## **Timbersled Mtn. Horse Snow Bike System**

### **Spindle Update Instructions:**

**Pic. 1**

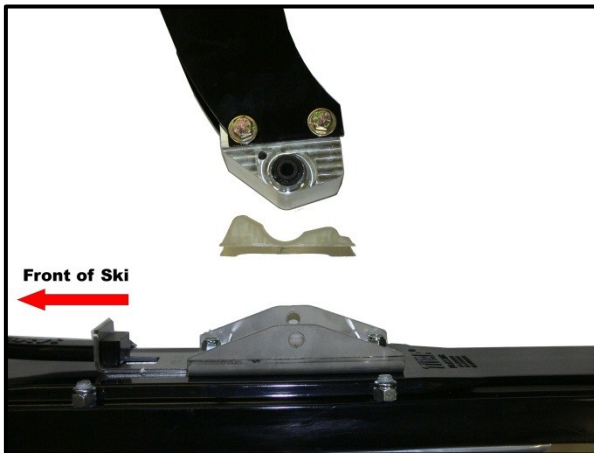
1. Remove the ski bolt.
2. Remove Ski and make sure the large (taller) side of the bumper is forward. See Pic 1.
3. Remove the 2 bottom spindle bolts.
4. Rotate the spindle block 180 degrees so that it matches that shown in pic 1.
5. Replace the bolts in the spindle block.
6. Replace ski bolt.
7. Torque all 3 bolts to 50 lbs.

**Pic. 3**

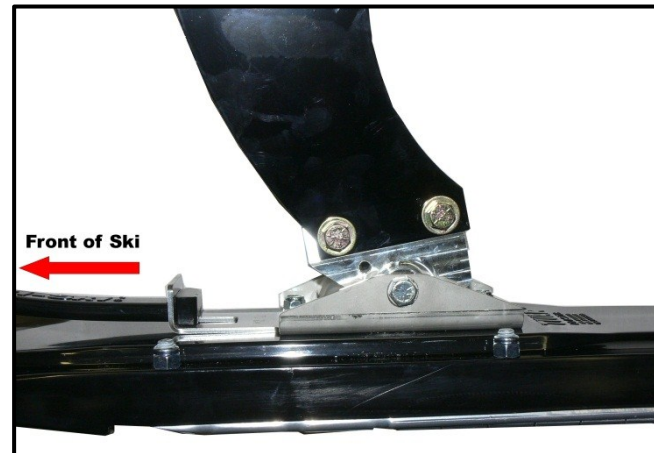
8. Remove the fork clamp bolts.
9. Rotate the spindle until the back of the fork clamp is flush with back edge of the spindle. See pic 3.
10. Drill a 21/64" hole through the spindle, using the fork clamps as a guide.
11. Place the fork clamp cap onto the fork tube.
12. Re-Install the 5/16" x 2 1/2" long Allen bolts and nylock nuts. Do not over tighten the bolt, you can break the clamp.
